CITY OF ALBUQUERQUE

PLANNING DEPARTMENT – Development Review Services

**RE: Desert Sands Subdivision
Drainage Report, and Grading and Drainage Plan
Engineer's Stamp Date 4-27-2016 (File: N09D014)**

**Re: Desert Sands Response to Drainage Report Comments
File Number N09D014**

TYPICAL LOT GRADING WITH SIDEYARD WALL

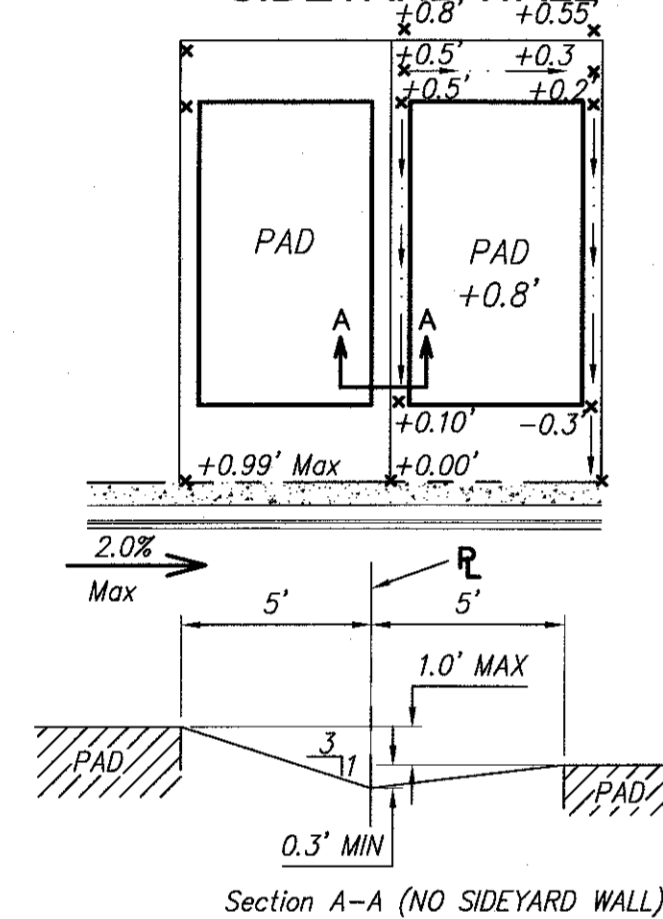
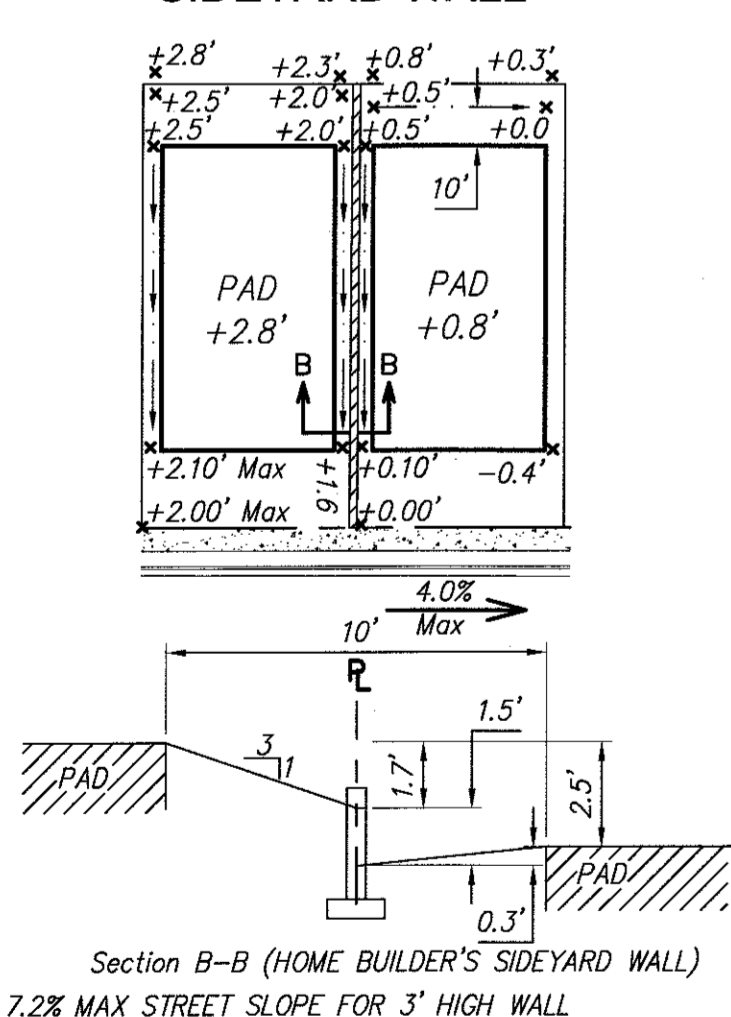
10. A approved ESC plan is required prior to approval for grading (or ESC permit)
11. Typ. Lot Detail w/ Sideyard wall: plan view shows street slope w/ 4% max, but section states 7.2% max. Typo? Also, provide the relative spot elev. at the front right corner of the lot.

TITLE: **DESERT SANDS SUBDIVISION
GRADING & DRAINAGE PLAN**

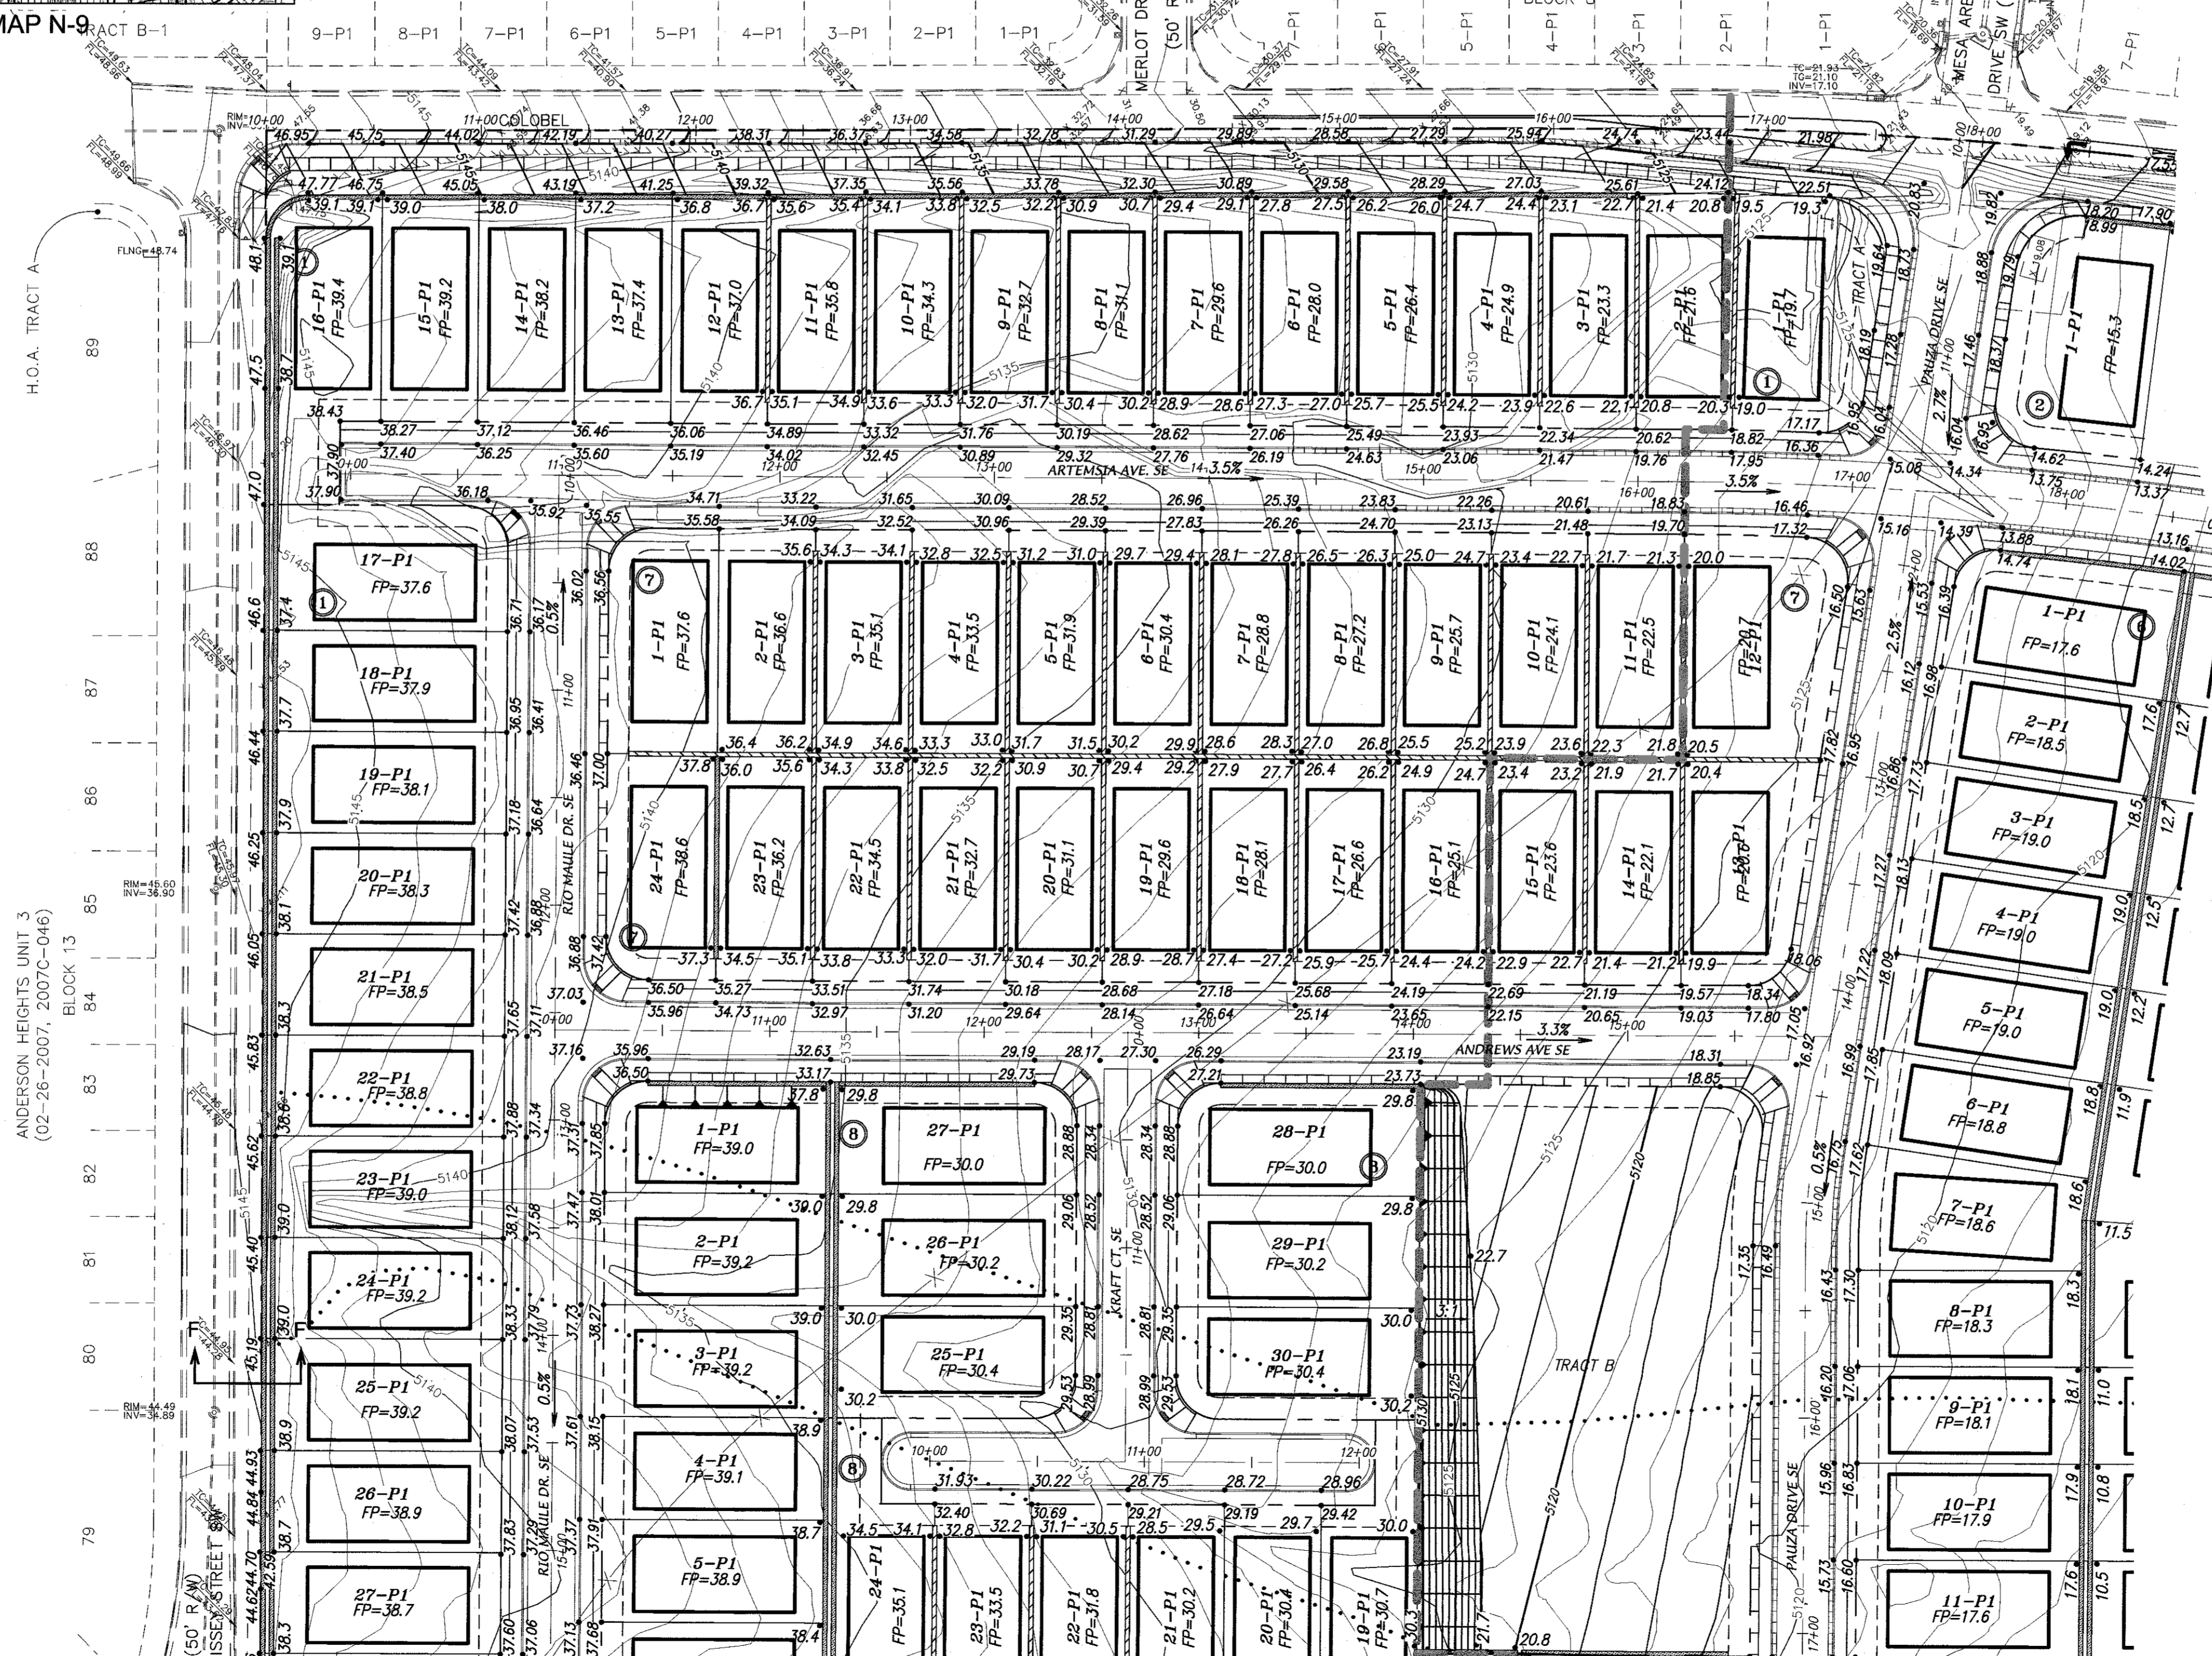
13. Lot 1-Block 8, Sht. 1: It is still not clear how the lot will discharge. Response did not seem to address my comment. Low point elev. 36.50 is at NW corner of lot at end of the retaining wall. If you provide a screen wall around the corner and no wall openings, ponding will occur within the lot. If you install wall openings, or if there is no screen wall, it will discharge thru the curb ramp, which is not acceptable.

f. Lot 1-P1: how will lot discharge? Low point seems to be at end of retaining wall. Will there be a screen wall around the corner? Runoff should not discharge should curb ramp. On lot 1 block 8 the pad is 2' higher than the grade at the top of the wall, and the wall is not intended to block or channel drainage.

Section K-K

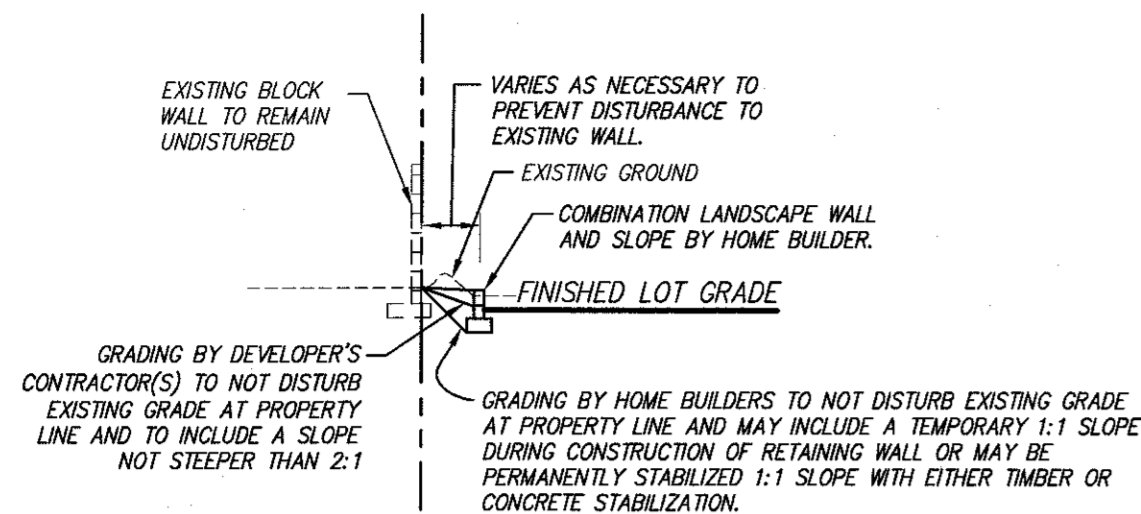
b. Retaining wall along southern boundary is shown right up against the existing screen walls and there may be constructability issues. Provide a section cut along the southern boundary. Section K-K has been added to sheet 3 of the G&D and note 12 has been added to sheet 1 to protect the wall on the south and the sidewalks on the west and east.

CITY OF ALBUQUERQUE PLANNING DEPARTMENT	
TITLE: DESERT SANDS SUBDIVISION GRADING & DRAINAGE PLAN	
DESIGN REVIEW COMMITTEE	CITY ENGINEER APPROVAL
LAST DESIGN UPDATE	MO./DAY/YR.
CITY PROJECT NO.	ZONE MAP NO.
SHEET 4	OF 5

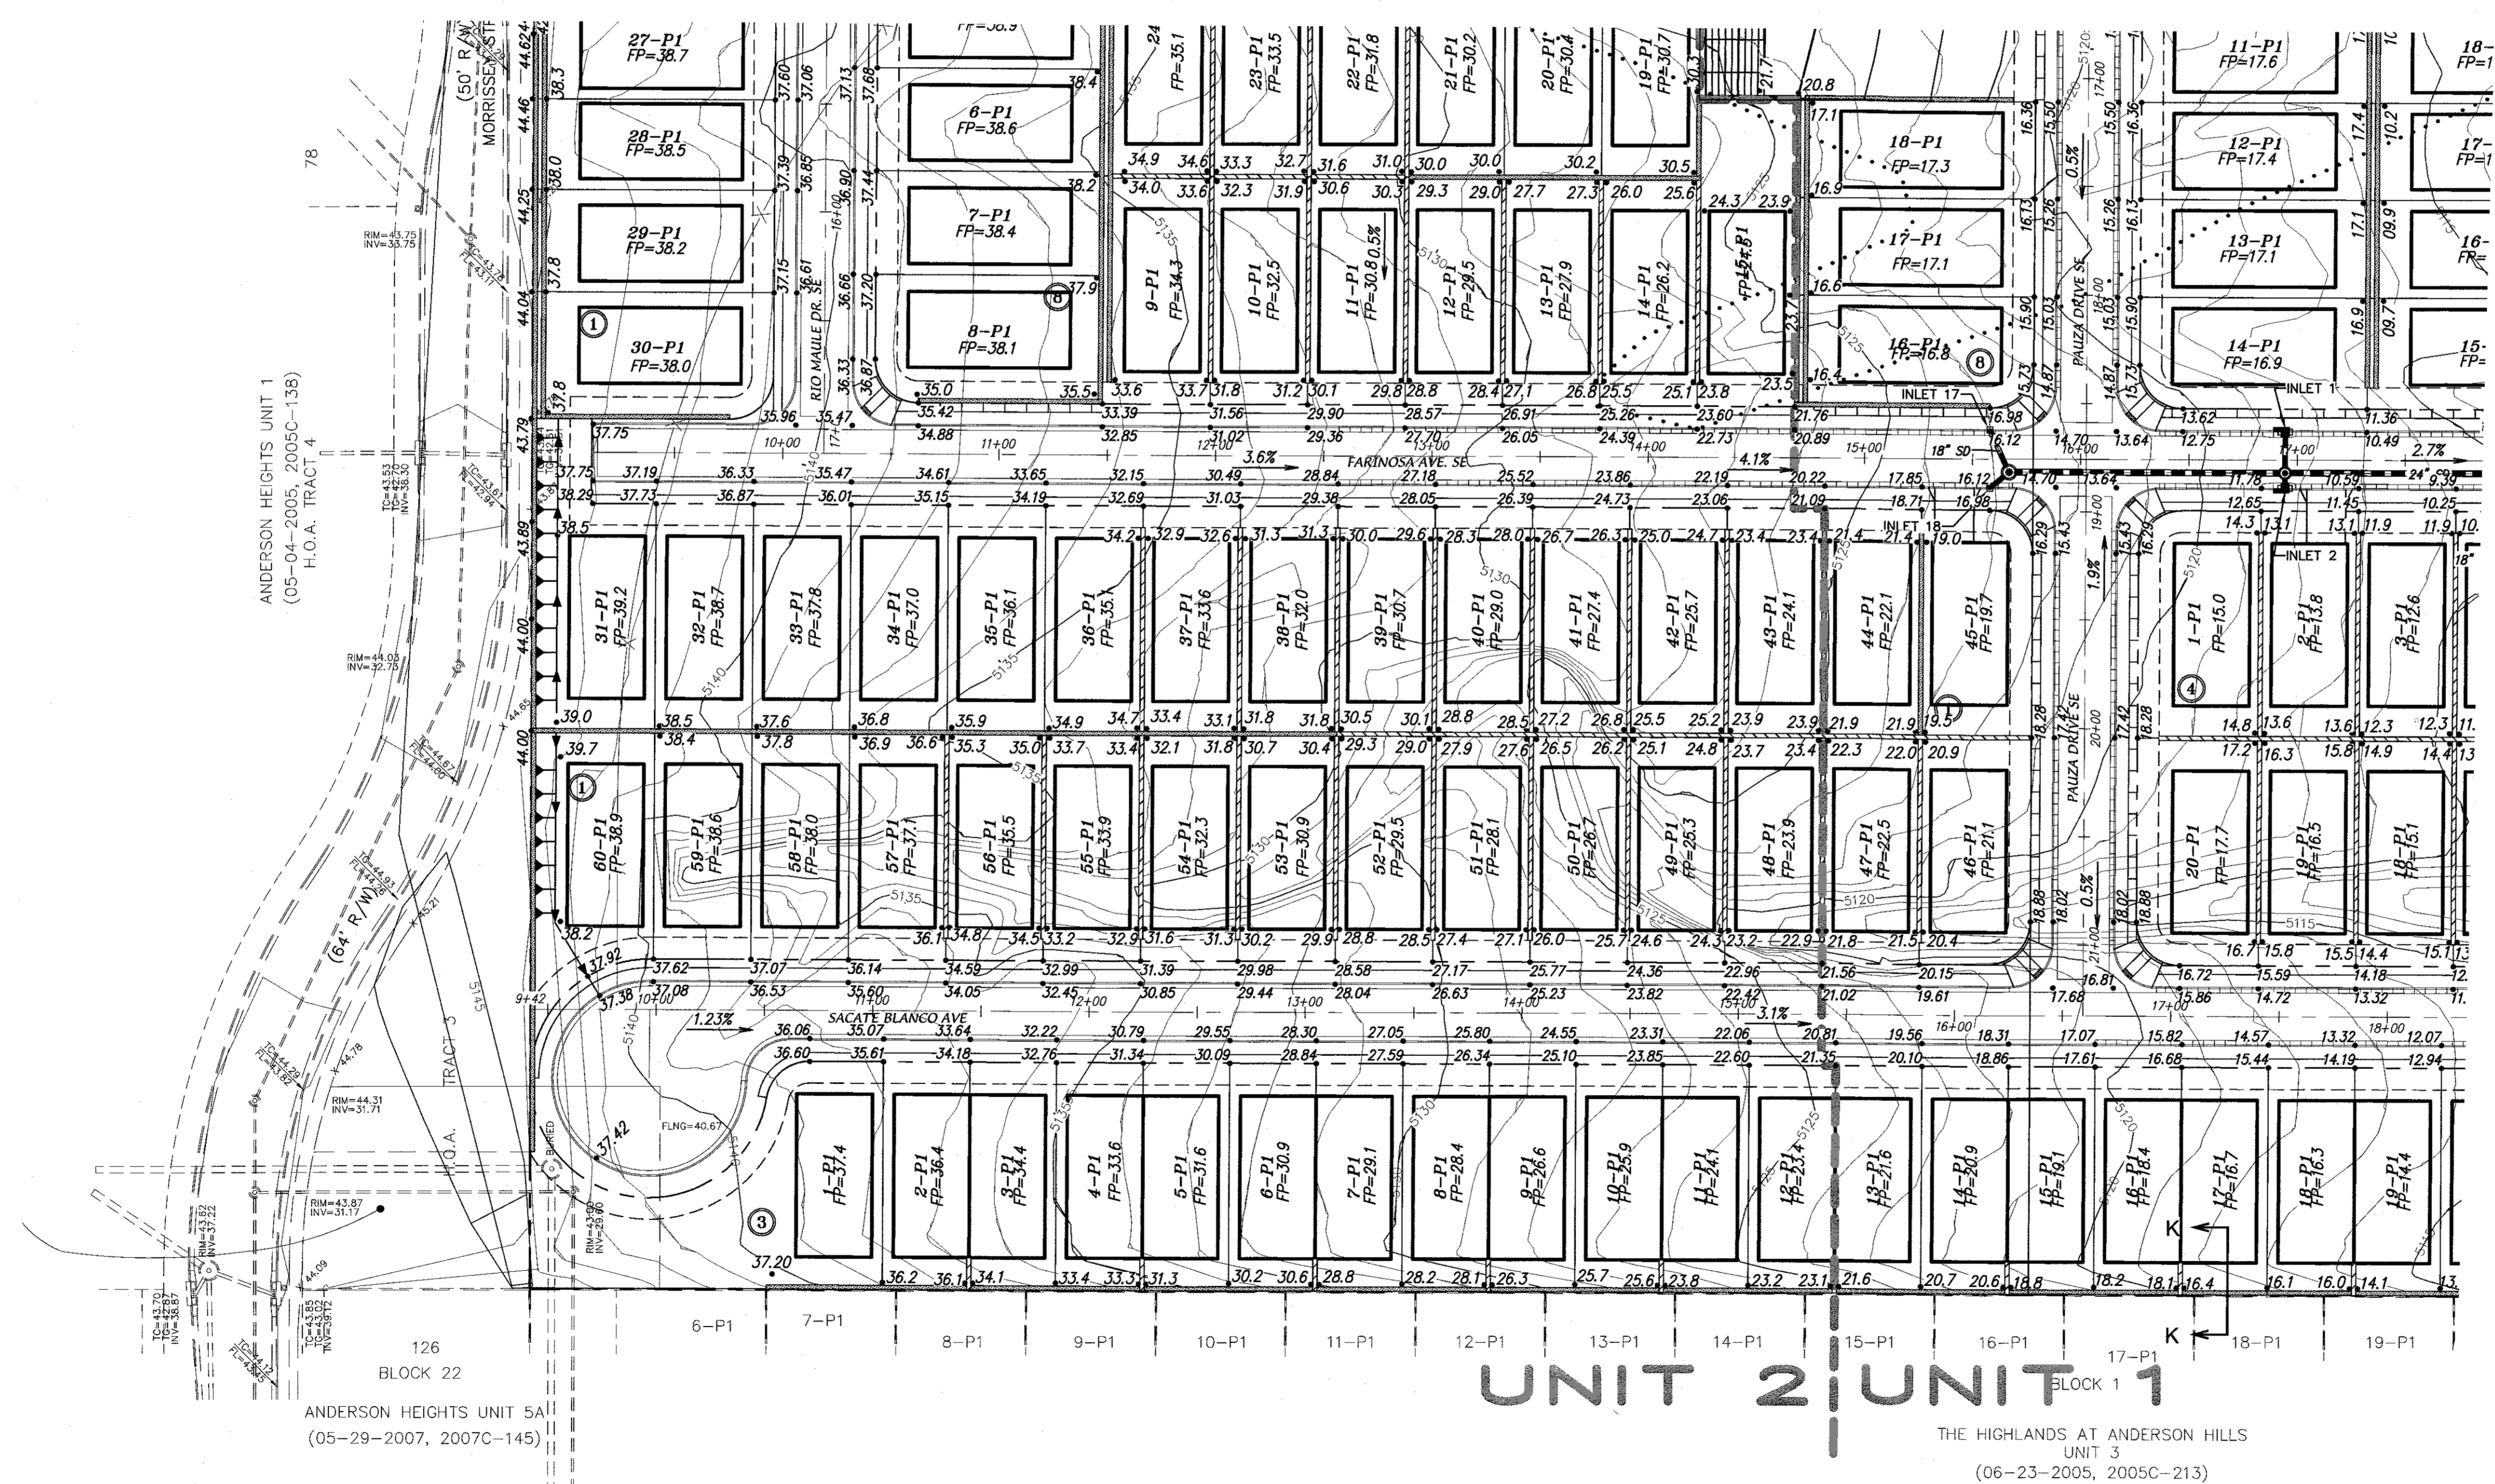
18. Sheet 4: Provide Contours At SW corner of subdivision. Provide T.O.Wall and B.O.Wall elevations along the retaining wall up to the end of Farinosa Ave. Verify that the retaining wall extends far enough south.

d. Provide FL EL. along Pauza Dr Elevations added to sheet 4 along Pauza Dr.
